# **GFA AD 597**

## **GFA AIRWORTHINESS DIRECTIVE**

Modification of the Canopy Jettison System

## SERVICE BULLETIN NO. MSB306-37 MSB320-08

MSB306-37/320-08 Page 4 of 5 13 June 2003

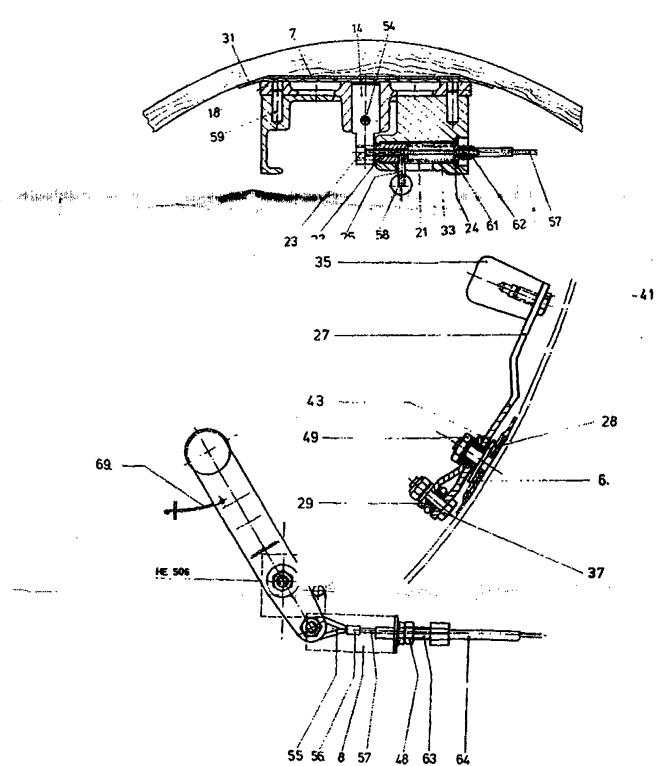
- 1.8.2 The canopy jettison operating lever including operating cable must be removed as follows (refer to illustration on page 4):
  - remove the RH cockpit covering
  - remove bolt (37)
  - cut-off cable (57) and remove adjusting screw (48) and remove completely operating cable (64)
  - remove safety wire (69)
  - remove nut (49) and operating lever (27)
  - cut-off cable (57) from canopy joint
  - remove cable rest with socket (62) and nipple (23)
  - install RH cockpit covering
  - remove placard "Canopy Jettision" from canopy jettison operating lever
